Docket Item #s 13 & 14
BAR CASE #2006-0180 &
BAR CASE #2006-181

BAR Meeting
October 4, 2006

ISSUE: 18 townhouses and waiver of HVAC rooftop screening requirement

APPLICANT: Van Metre Investments, LLC

Figure 6 - Side elevation corresponding to locations 1, 7, 12 & 18

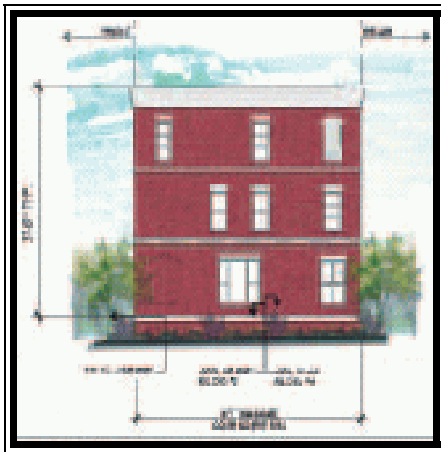
The side elevations at locations 1, 6, 7, 12, 13 and 18 will be more readily visible than the rear elevations from the public right-of-way. There will be two types: one having a mansard profile and corresponding to front elevation type D and E; and one with a flat roofline corresponding to front elevation type C. The side elevations are clad in brick and have brick watertables and string courses. The window configuration (either one-over-one or two-over-two) is continued from the

front. The flat arched window heads and the sills will be of brick. Each story will have a different fenestration pattern, with single or grouped windows. Four windows on the side elevation for location 6 and 13 will have panels in the lower portion of the opening, due to interior constraints. The drawings do not give the material for the panels, but the architect has described them as synthetic board with MDO trim. An arched, recessed blind opening is utilized at the front of the first story. An arched opening with railing at the rear of the third story opens onto the rear inset balcony. The side elevation for locations 1, 7, 12 and 13 will have a oriel window on the first story toward the rear. This window will project slightly from the facade.
